LRN-01-0412
LCR S01-08

**EXIGENT REQUEST FOR CHANGE TO TECHNICAL SPECIFICATION 3/4.7.4
SERVICE WATER SYSTEM
SALEM GENERATING STATION UNIT NO. 1
FACILITY OPERATING LICENSE DPR-70
DOCKET NOS. 50-272**

**SALEM GENERATING STATION
UNIT NO 1
DOCKET NOS. 50-272
CHANGE TO TECHNICAL SPECIFICATIONS**

FIGURE 1
SALEM UNIT 1 SERVICE WATER SYSTEM

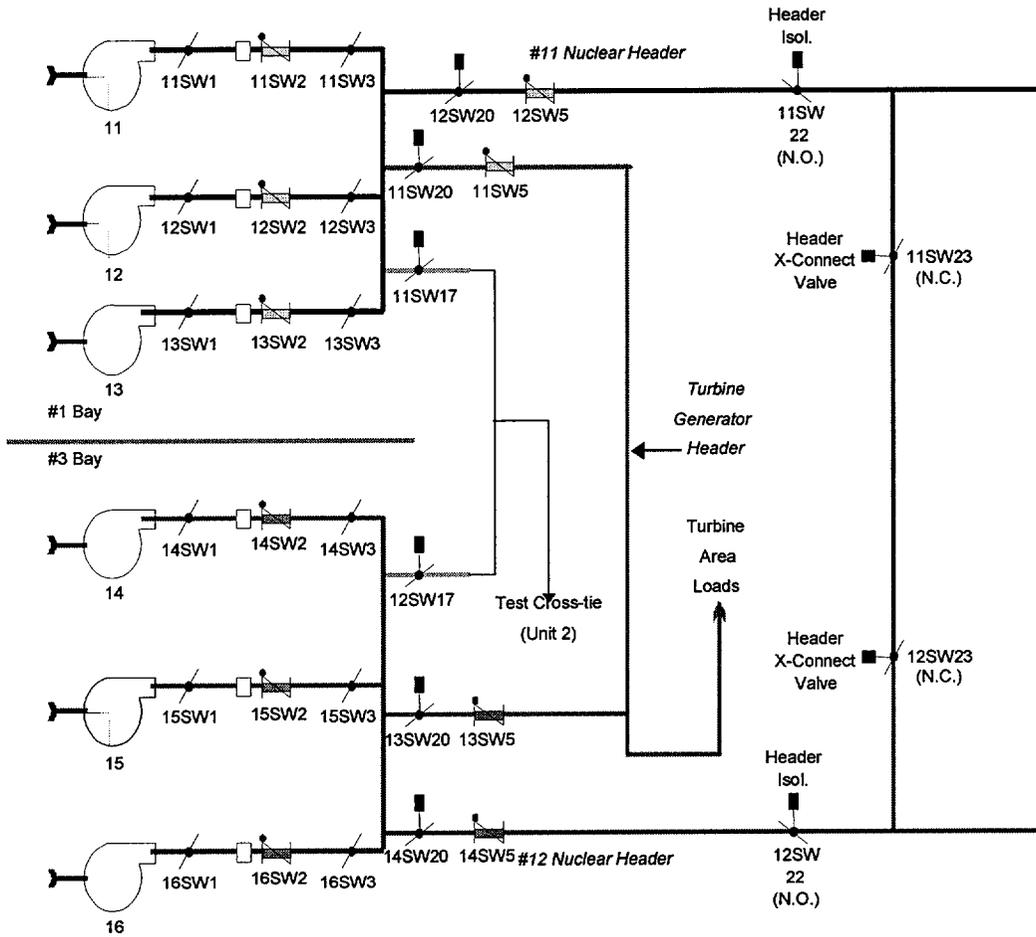
On Friday morning, November 30, 2001, Operations personnel noted water rising up through the gravel in front of the Service Water intake structure. The water was located approximately five feet from the structure and seven feet from the north side stairs, the 12 Service Water nuclear header is located below the location where the water was observed and was considered to be a likely source of the leak.

Subsequent investigation and troubleshooting determined that the leak is associated with the 12 Service Water nuclear supply header. This determination was partially based on the use of a dye test. Based on the information currently available, the leak is postulated to be at an underground mechanical joint or mechanical connection associated with the buried portion of the 12 Service Water nuclear supply header located near the Service Water structure. A simplified diagram of the service water system is provided in Figure 1.

Two repair options are being considered: (1) use of an internal mechanical seal or (2) repair or replacement of the affected section(s) of the buried concrete pipe. The appropriate repair option will be decided after the internal inspection and evaluation are completed. However regardless of which repair option is selected, the SWS will be capable of performing its intended safety function, which is to provide sufficient cooling capacity to safety related equipment during normal and accident conditions.

To perform the selected repair method, the buried portion of the 12 service water nuclear header will be isolated such that all six service water pumps will be available and capable of supplying cooling water to the safety related equipment via the redundant nuclear header (number 11 header). In this configuration, the UFSAR assumption that two pumps per bay, and at least one powered from each vital bus, are available to mitigate the consequences of a Loss-of-Coolant Accident with a loss of power is maintained. To isolate the leaking section of the buried portion of the 12 nuclear header, the number 3 service water intake bay will be isolated temporarily to permit installation of a blind flange. The total period of time during which the number 3 bay is isolated will be limited to less than the 72 hours currently permitted by TS 3/4.7.4.

During the repair to the 12 nuclear service water header, the header will be isolated such that all six service water pumps will be available and capable of supplying cooling water to the safety related equipment via the redundant nuclear header (number 11 header). To isolate the leaking section of the 12 nuclear header, the number 3 service water intake bay will be isolated temporarily to permit installation of a blind flange. The total period of time during which the number 3 bay is isolated will be limited to less than the 72 hours currently permitted by TS 3/4.7.4.
